Service Bulletin No. 28

SUBJECT: (Gear- Driven) Flap Control Mechanism Inspection for the installation of the (Roller) Bushing located at the juncture of the safety-wired Connecting Link Spring Clips located at Turnbuckle Rod Eye Ends.

AIRPLANES AFFECTED: All Maule models certificated from January 1, 2004 to May 1, 2007.

(Partial) Flap Control Mechanism Bottom Turnbuckle & Chain
(View Looking from Right Side of Aircraft)

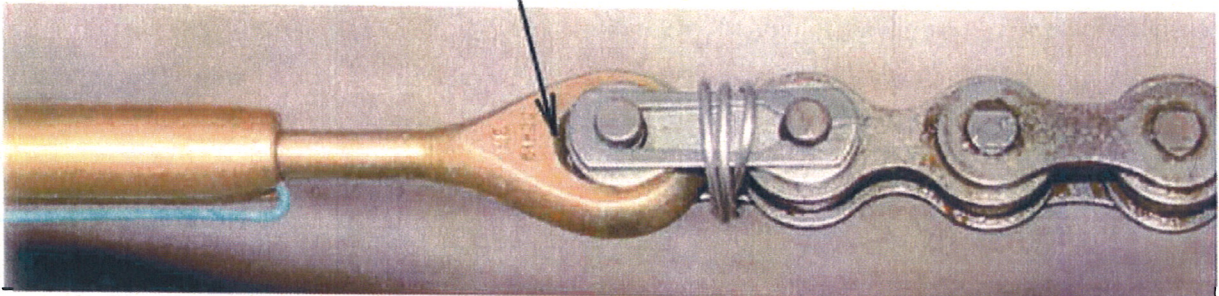
Note: Proper Installation of Bushing in Rod Eye End. Observe no "daylight" gap.

(Partial) Flap Control Mechanism Bottom Turnbuckle & Chain
(View Looking from Right Side of Aircraft)

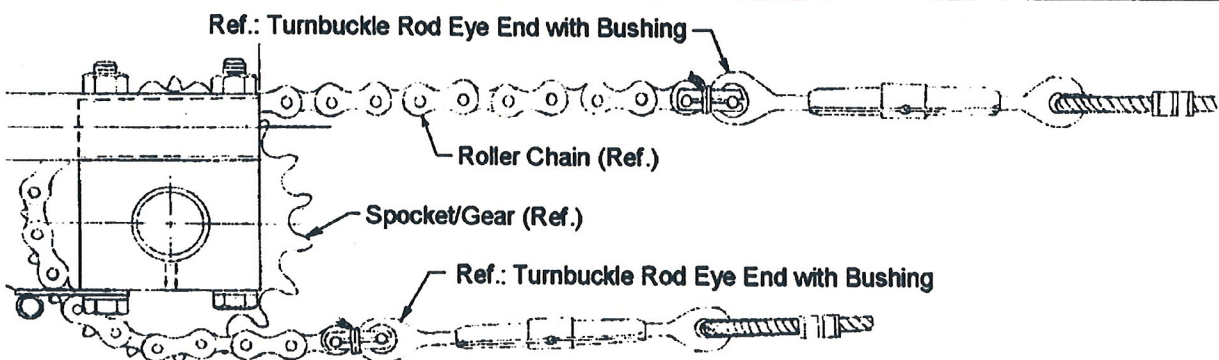
Note: Bushing "missing" from Turnbuckle Rod Eye End. Observe "daylight" gap.

Note: Top Turnbuckle Treatment identical to bottom Turnbuckle.

1. Locate 2nd Access Zipper in Cabin Headliner aft of Dome Light Assembly.
2. Unzip (Flap Control Mechanism) Access Zipper and visually inspect both Turnbuckle Rod Eye Ends as per Maule Diagrams on Sheet 2.
3. If the (Roller) Bushing is found to be missing on either top or bottom, (or both) Rod Eye Ends, contact the factory at (229) 985-2045 to request a replacement(s) Turnbuckle Rod Eye End with Bushing Insert at no charge. Contact persons for part(s) will be Bryan Horne @ Ext. 239, or Barry Miller @ Ext. 223.
4. Following inspection and replacement of Rod Eye End with Bushing, if required (Ref. Note #3), fill out the accompanying Compliance Record Sheet (page 3) and return to Maule Aerospace Technology, Inc. Note in the Aircraft Logbook that Maule Service Bulletin No. 28 has been complied with.
